**Hydrothermal Characteristics of
the Nechako Reservoir**

The Nechako Enhancement Society

**Gregory A. Lawrence, Ph.D., P.Eng.
Roger Pieters, Ph.D.**

27 April 2005

Figure 1. Computed Time Varying Water Temperatures at the Kenny Dam Release Facility for Supplementary Extreme Conditions Hydrothermal Modelling, March, 1979 to December, 1981 (a) Case 22a and (b) Case 23. (From Triton, 1992)

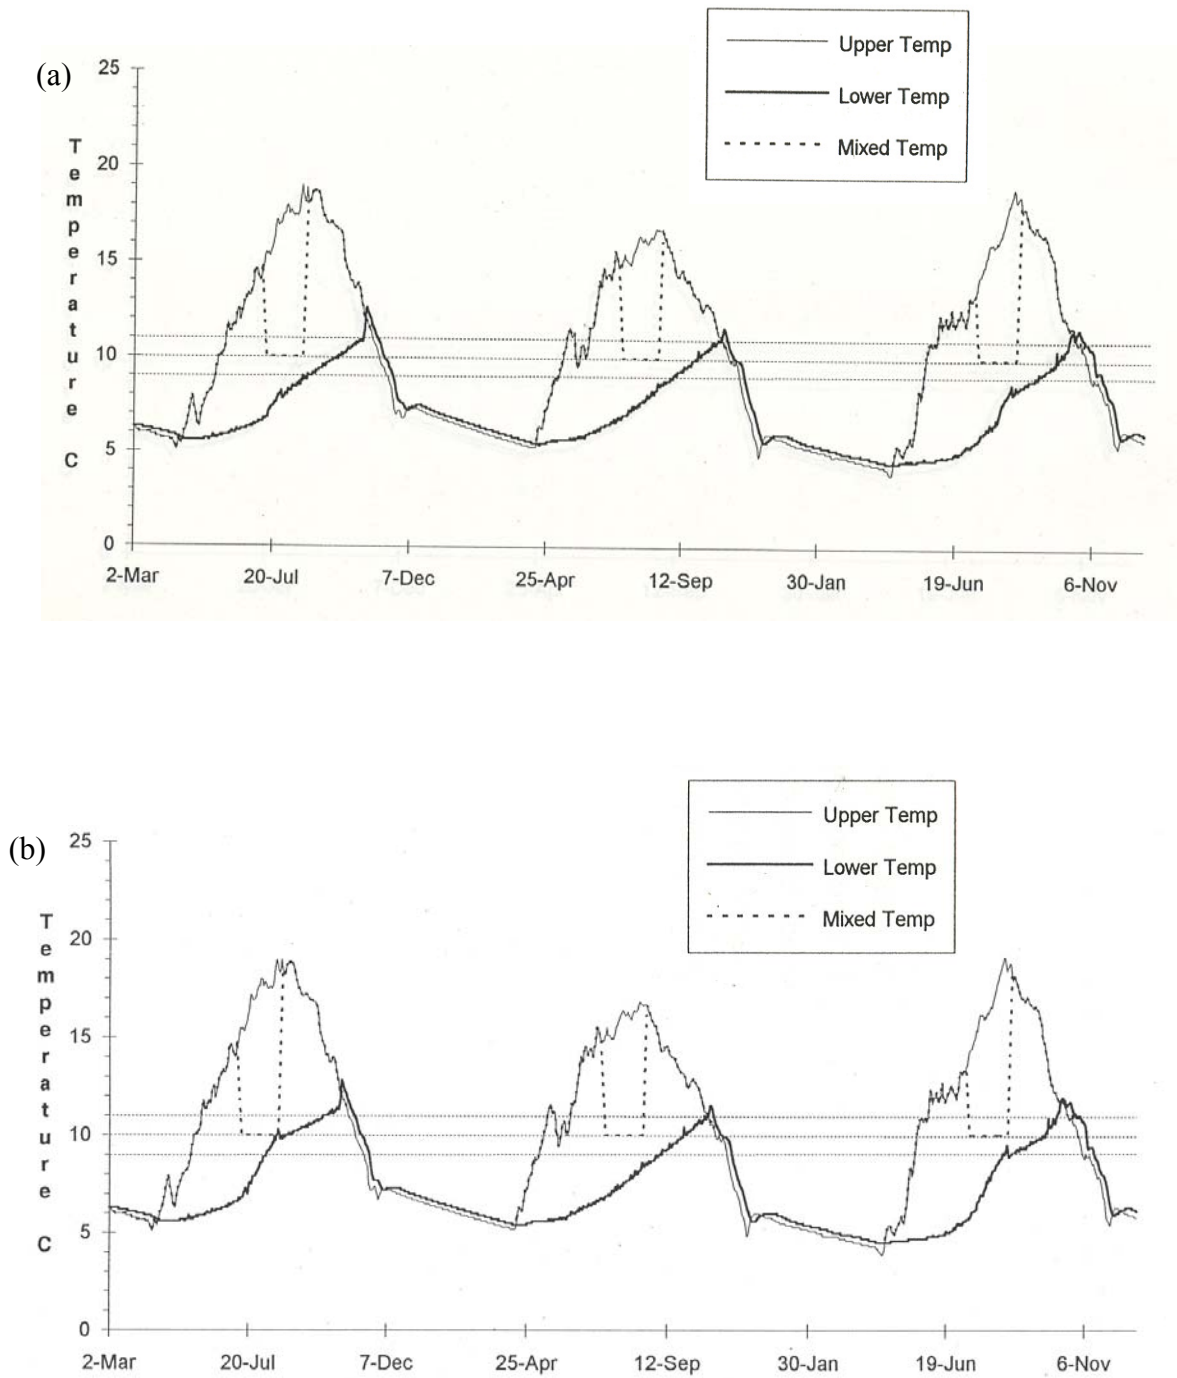
In the most severe case (23a) the 10 C criteria was exceeded when the intake temperature reached a maximum of 10.2 C on August 20, 1979 the last day of the 32 day cooling period, see Figure 1b. However, it would be inappropriate to regard this as “failure” of the facility. Triton (1992) put this result in perspective by noting that the only time KDRF would be required to provide 170 m³/s at 10 C for 32 days would be when 200 year (or greater) return period conditions in the Nechako River basin persisted for 32 consecutive days.

The results from Case 22a are presented in Figure 1a. The maximum predicted deep-water intake temperature is 9.0 C. This predicted temperature could be in error by 1 - 2 C, and the 10 C criterion would not necessarily be satisfied. Similarly, the maximum predicted deep-water intake temperature for case 21 is 8.7 C (Triton 1992), which is also within the margin of error of the model predictions. However, for the moment we will assume that the predictions of the model are accurate.

Figure 2. Modelled position of the 10 C isotherms for Case 22a in the context of CWRf.

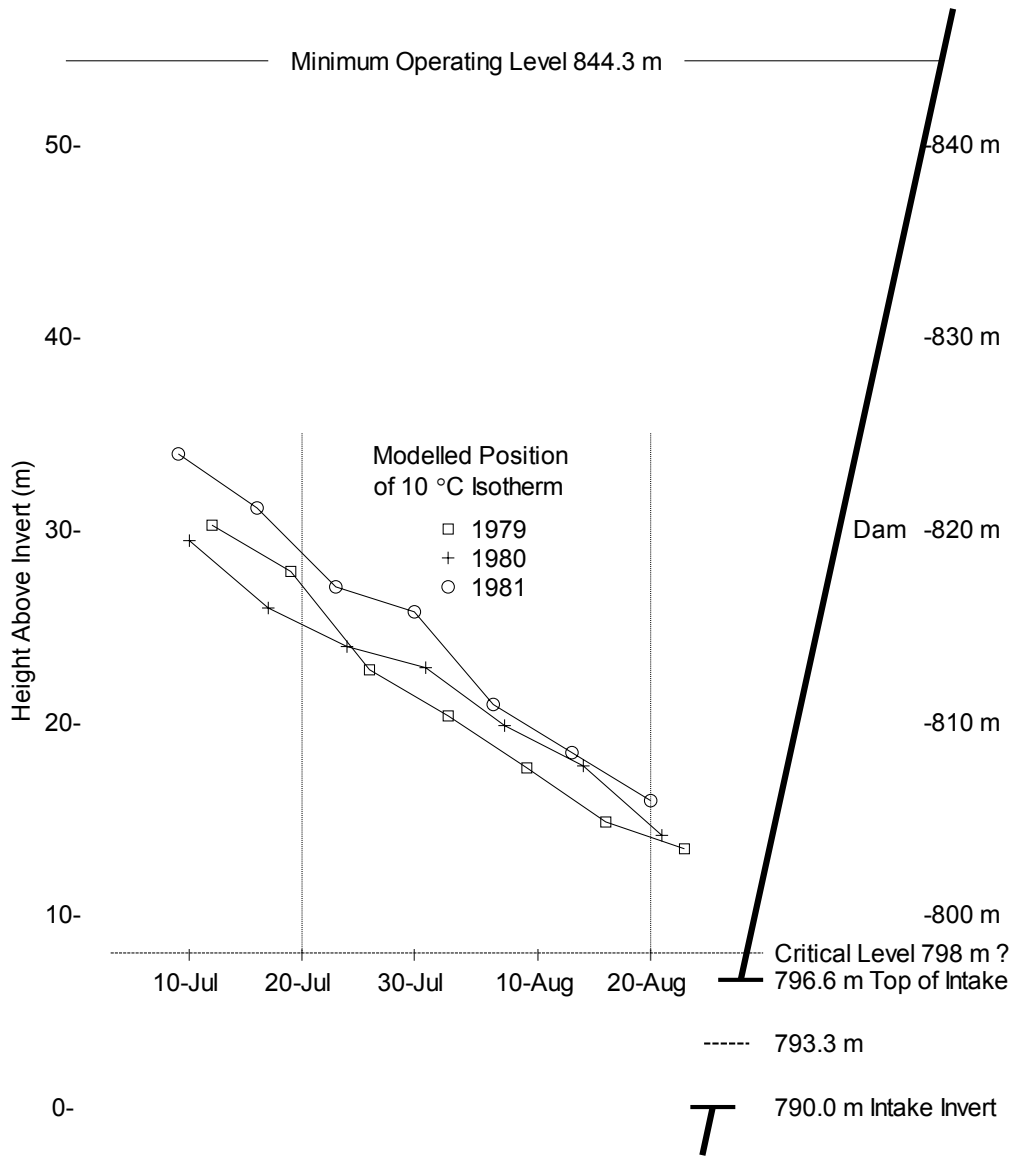
The modelled position of the 10 C isotherm in Case 22a is shown on Figure 2. The lowest predicted level during the summer cooling period is 804 m on August 20, 1979. Given that the proposed intake extends from 790 m to 796.6 m it might seem that the facility could easily

deliver sufficient quantities of 10 C water. There are however two other factors to consider: selective withdrawal and internal waves.

The importance of answering this question is illustrated in Figure 2. A relatively small depression of the modelled 10 C isotherm (~6 m) would result in greater than 10 C water being withdrawn through the intake. Given uncertainties associated with the modelled results and the position of the critical level, internal waves are a cause for concern.
